A12 Chelmsford to A120 widening scheme

TR010060

DEVELOPMENT CONSENT ORDER CHANGE APPLICATION CONSULTATION

Junction 25 Technical Note

Plate 1.1 Redesign of junction 25 to signalised roundabout

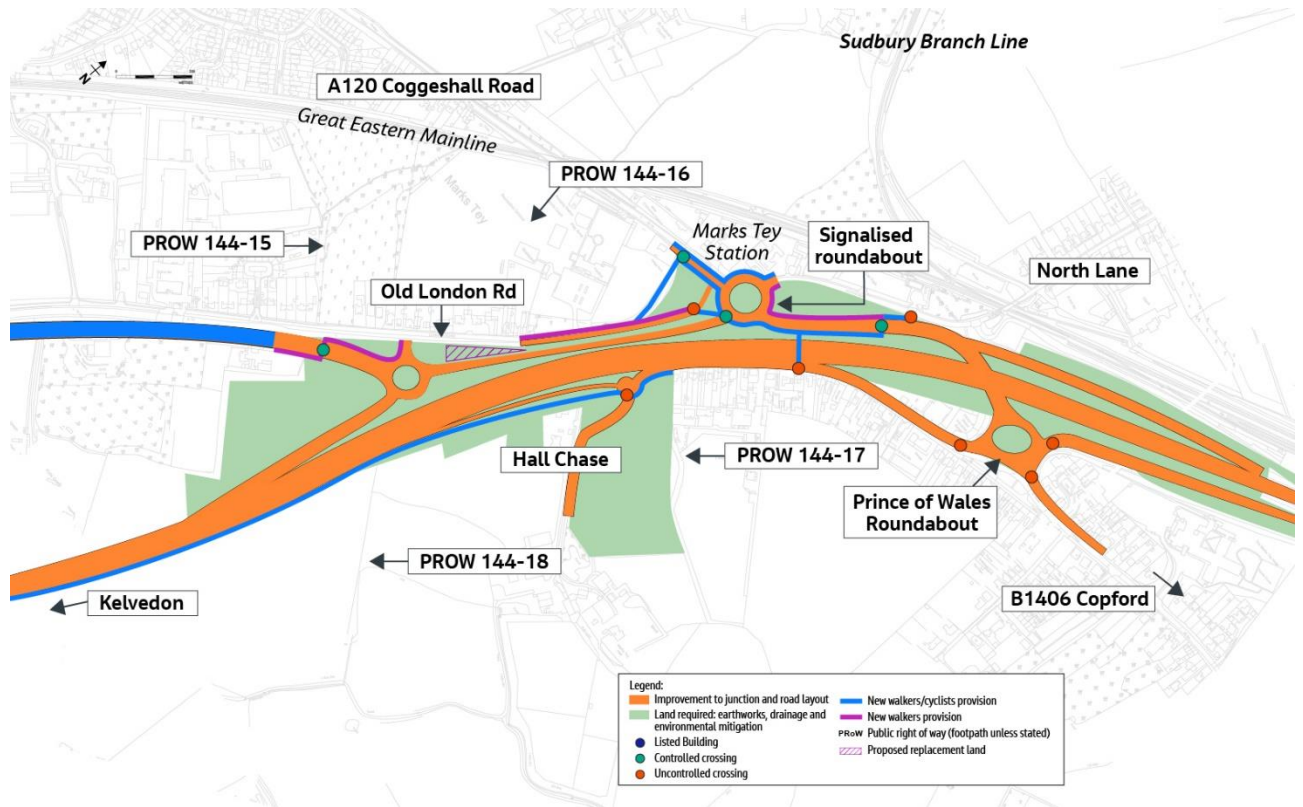
- 1.2.1 National Highways is proposing to change the configuration of junction 25 to remove the signalised crossroads proposed in the design submitted with the DCO application, and implement a partially signalised roundabout design to maximise the use of existing infrastructure and minimise loss of existing trees within the Old Rectory Junction roundabout island. The retention of the roundabout, albeit with its signalisation, requires less land acquisition and has small impacts on the proposals for replacement land in this location. There will also be consequential changes to the utility diversions in this area.

replaced by a signalised all movements crossroads. Through further design refinement as part of the detailed design process happening in parallel with the DCO examination, the traffic signal phasing for the signalised junction has been refined and an optimal solution has been identified which would allow a partially signalised roundabout design to be implemented. This would also allow the proposals to satisfy the request of Marks Tey Parish Council to retain as many trees within the existing Old Rectory Junction roundabout as possible.

Plate 3.1 Change in traffic flows around Junction 25 (2027 traffic flows)

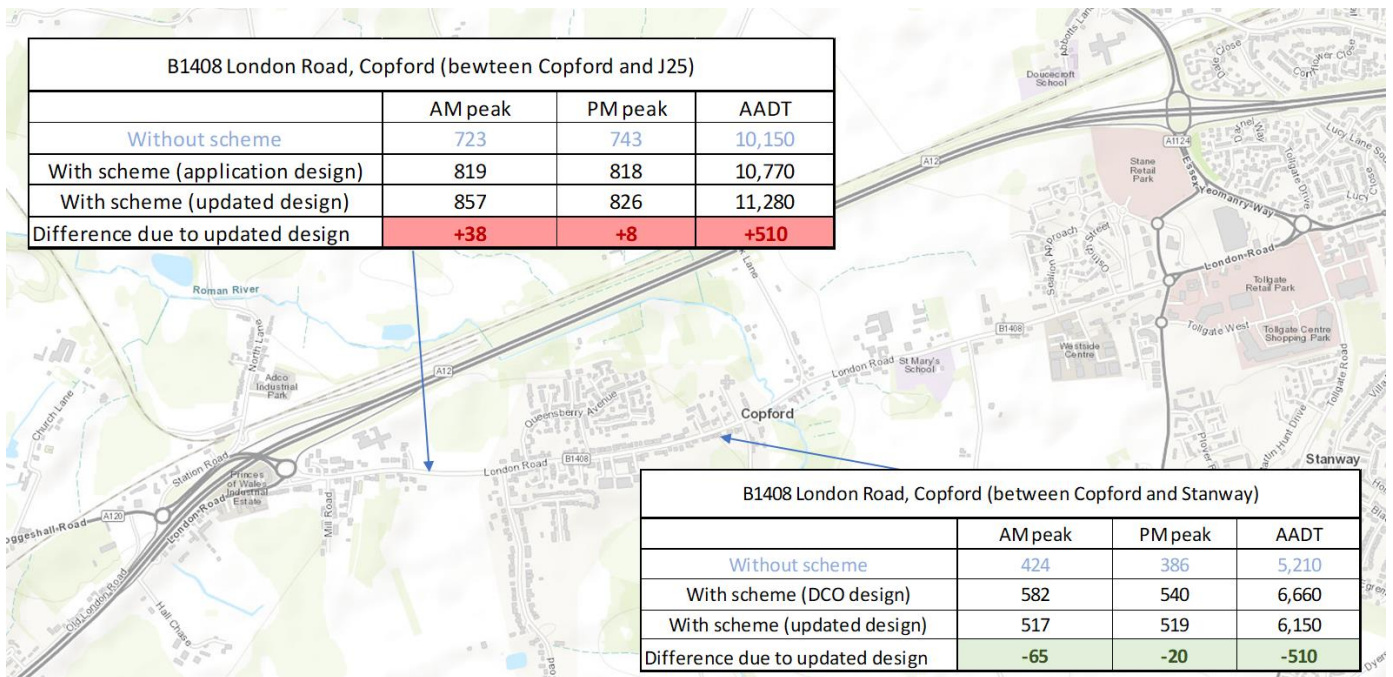
- 3.3.9 The change in traffic flow on these roads is shown below. This shows the predicted change in 2027 traffic flows as a result of the new design. The traffic flows are presented in vehicles per hour in the AM and PM peak, and in vehicles per day (AADT). For example, traffic on the B1408 between Copford and Stanway is predicted to be 65 vehicles per hour lower due to the proposed change than it would have been with the design presented in the DCO application.
- 3.3.10 The impacts that this change in traffic would have on noise and air quality impacts is described in section 3.4 of this report.
- 3.3.11 Although the traffic model also predicts some changes in traffic on other roads, only the changes around Copford and Marks Tey are considered significant enough to report. Any changes on other roads are much lower.

- 3.3.12 In summary, junction 25 itself would perform better as a result of the proposed change. Traffic flows would decrease on the B1408 London Road through Copford, but would increase slightly around A12 junction 25 itself however not to an extent that this would impact on the operation of any other junction or local road.
